Office Action Summary

10/605,623

MELENDREZ, JULIAN B.

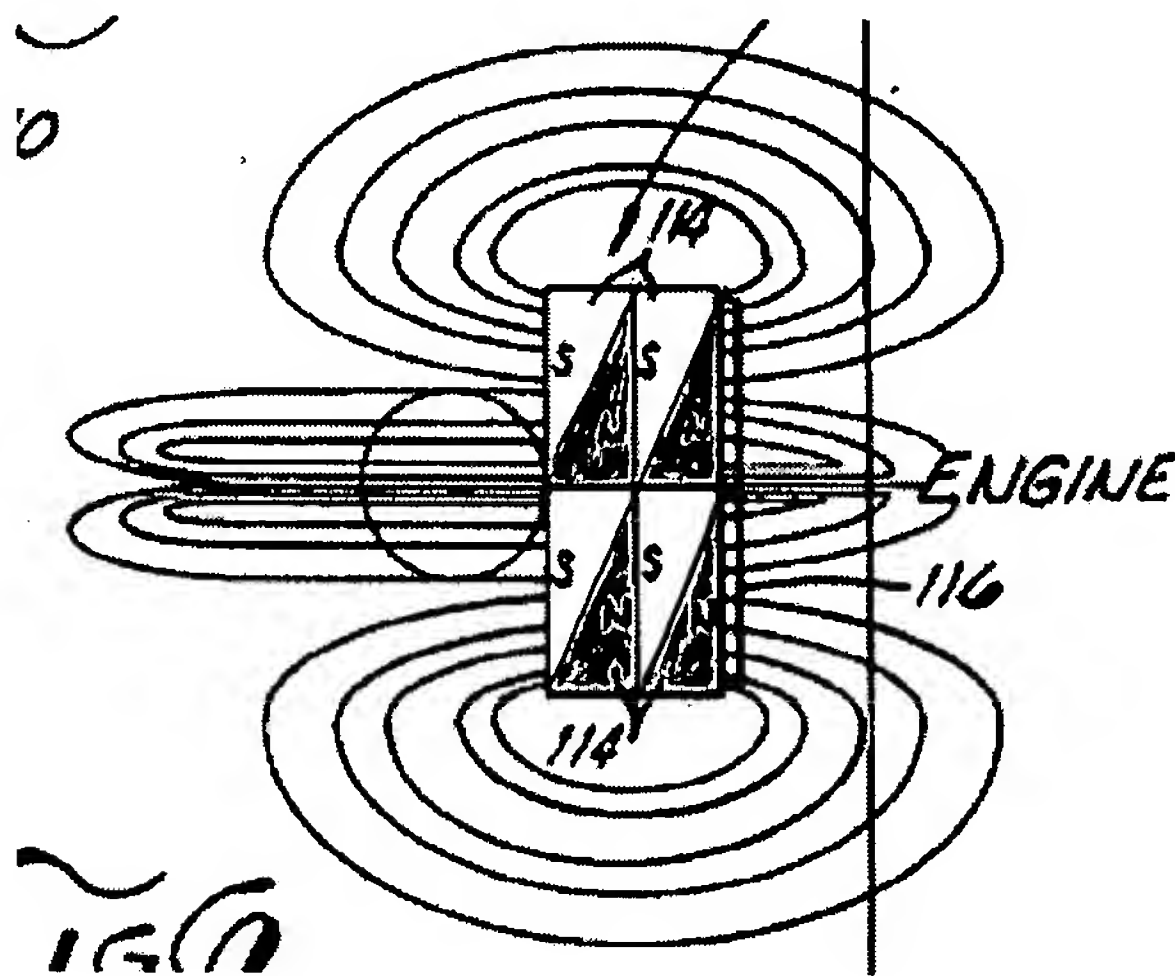
Applicant has attacked the viability of the Ettehadieh reference by claiming that the magnets are configured such that like polarities are in direct contact with each other. This argument is based on an assumption that the divisions between the poles is parallel to the long sides of the magnets, as shown in the Figure drawn by Applicant in the Appendix to the Remarks/Arguments. If this assumption were correct, Ettehadieh would have problems, as suggested by Applicant. However, this assumption is not supported by any solid evidence in the Ettehadieh reference. The manner in which the poles are shown in the Figures of the Ettehadieh reference and particularly the manner

in which the flux lines of force are drawn in the Ettehadieh reference suggests that a different assumption is more likely to be true, as shown below:

The Figure (Figure 6 of Ettehadieh) shows the poles such that the north poles are shaded (by the examiner to indicate the examiner's assumption about polarity division) and the south poles are left white. This kind of division between the poles can be assumed by the manner in which the poles are referenced and is consistent with the lines of flux shown emanating from the magnets, and allows the magnets to function without the problems obtained when assuming that the poles are divided by lines parallel to the long side of the magnets (i.e. vertical, in the case of Figure 6), as Applicant has. Since Ettehadieh is silent as to exactly the manner in which the poles are delineated, it makes sense to the examiner to make the assumption which would allow the device of Ettehadieh to be operable, rather than to assume that Ettehadieh would configure the polarity of the magnets, such that the device would be inoperable.
